Addendum To 7370 Dial Long Line Repeater Circuit

1.01 This addendum is issued to revise Section 7370-101/3 and to serve notification that the attached schematic diagrams 191-737000, Issue 2, and 191-737001, Issue 1, have been updated to revision level E.

SCHEMATIC DIAGRAM
MODEL 7370
DIAL LONG LINE REPEATER

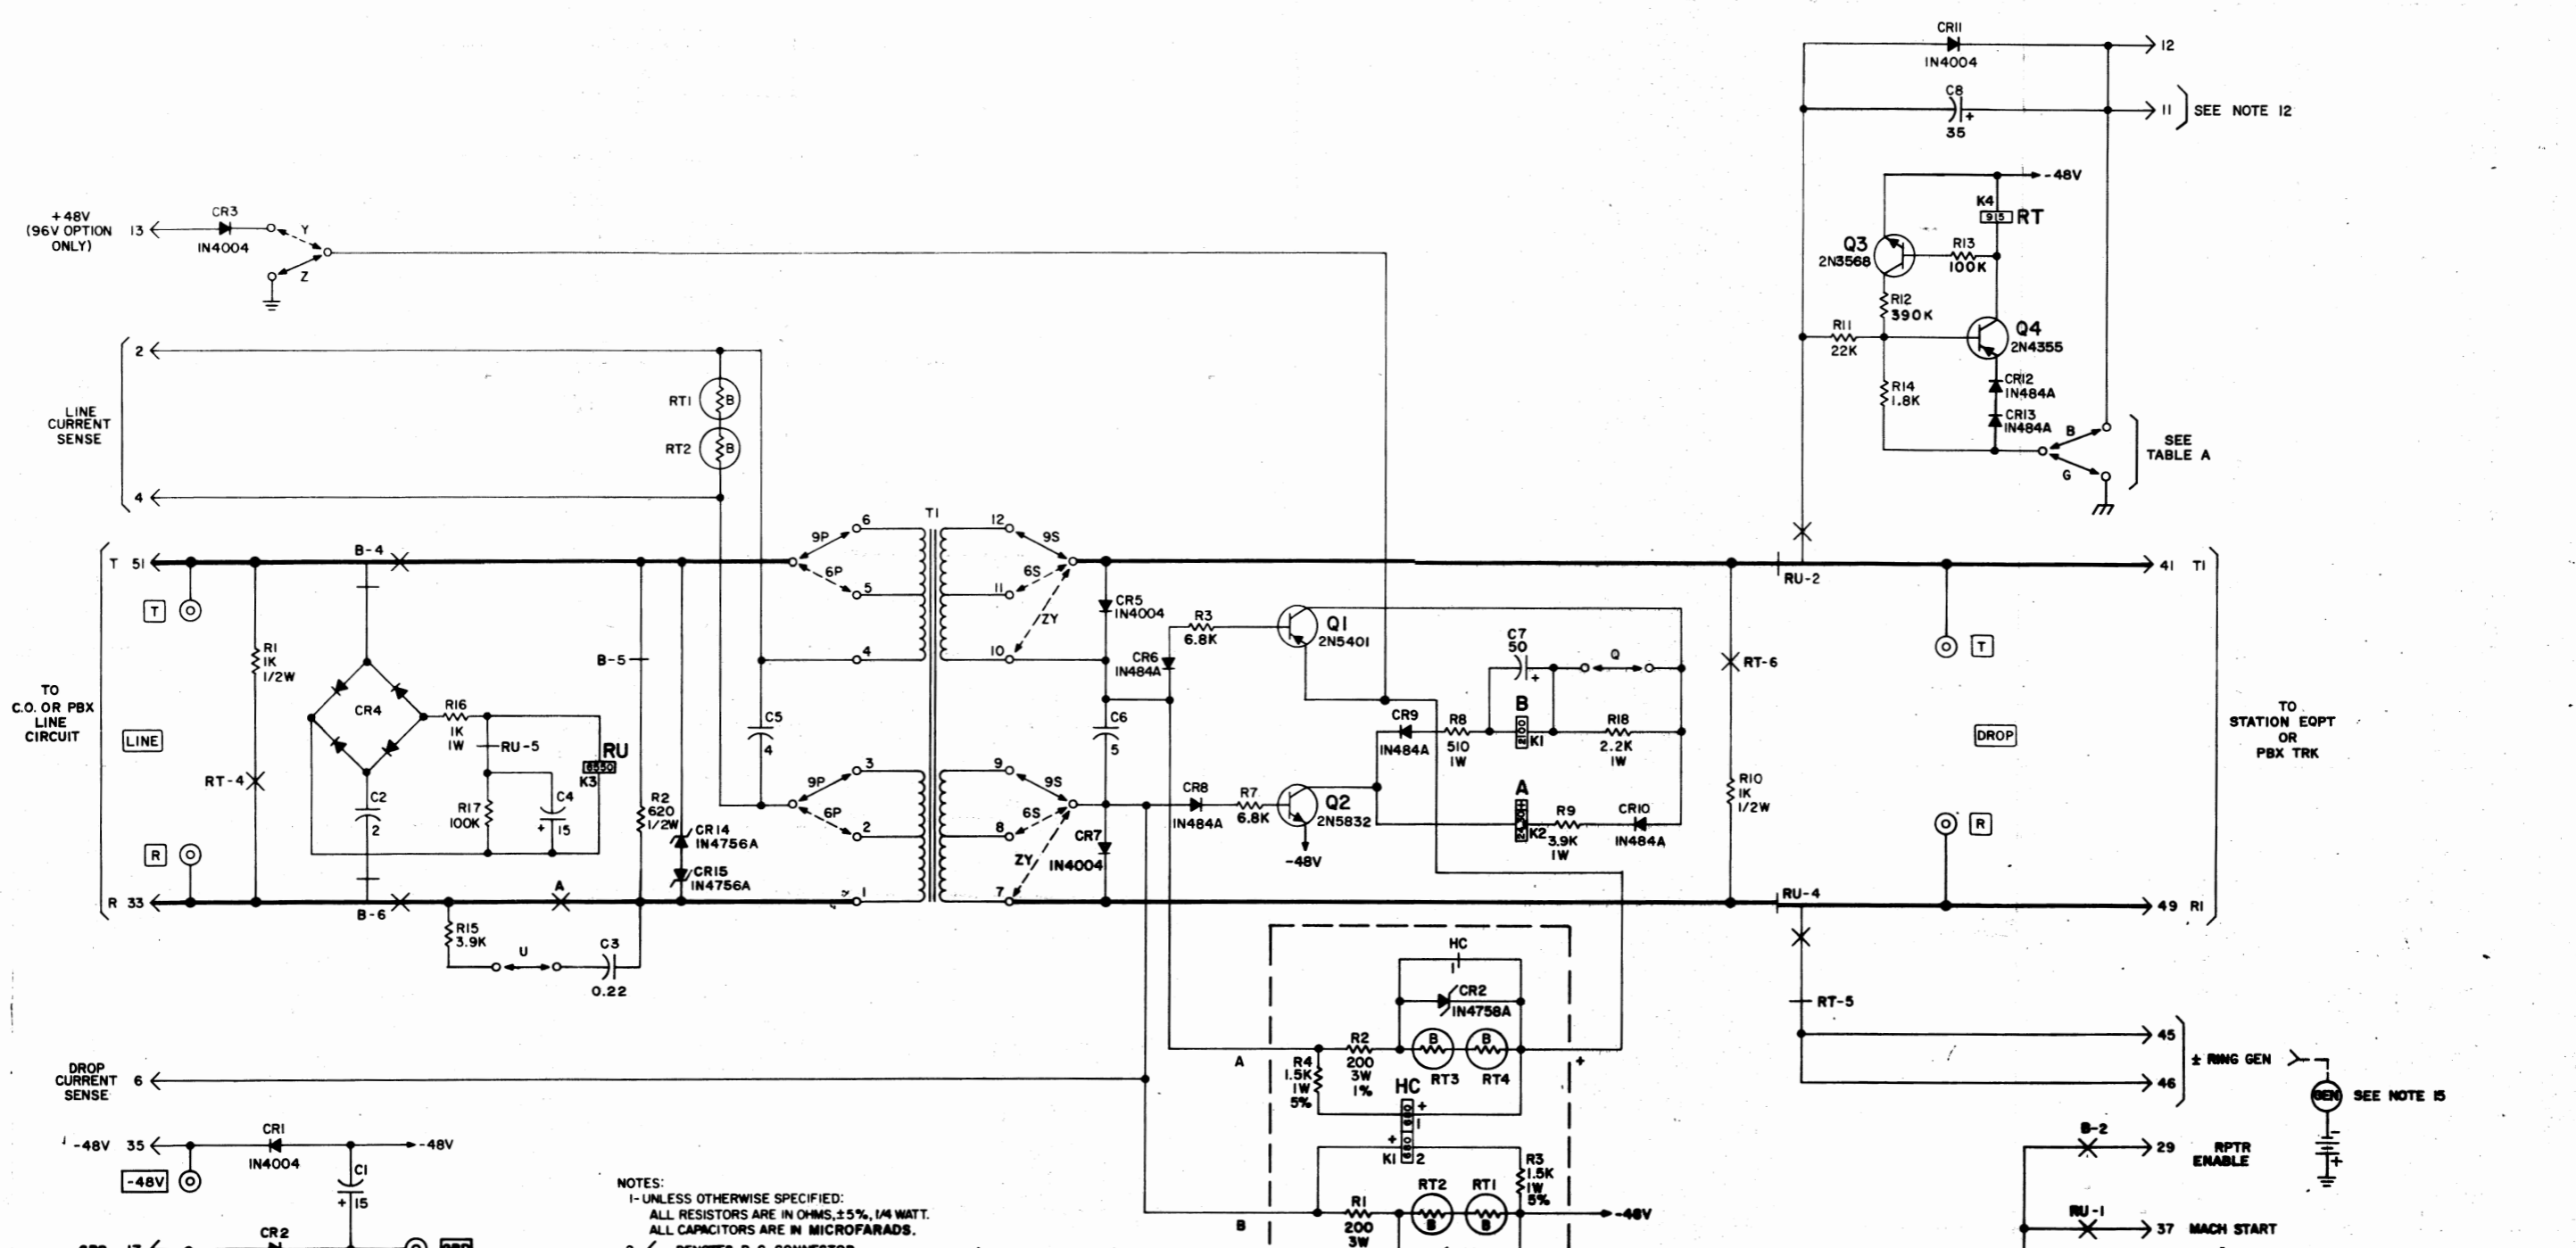
2.01 On page 6, change the ending of the first sentence of paragraph 6.09 from "lamps DS-1 through DS-4 and associated circuitry." to "resistance lamps RT1 through RT4 and associated circuitry."

2.02 On page 6, change the middle of the last sentence of paragraph 6.09 from "lamps DS1 through DS-4" to "resistance lamps RT1 through RT4."

| ISS/REV | ECO NO. | DATE | CHANGE | REASON | ADDENDUM |
|---------|---------|-------|---|---|---------------|
| 1/E | 2360 | 4/73 | Changed rating of resistance lamps RT 1 through RT4. | To improve loop current range. | A |

| ISS/REV | ECO NO. | DATE | CHANGE | REASON | ADDENDUM |
|---------|-----------------|-------|--|--|---------------|
| 2/E | 2360 | 4/73 | Changed rating of resistance lamps RT1 and RT2. | To improve loop current range. | A |
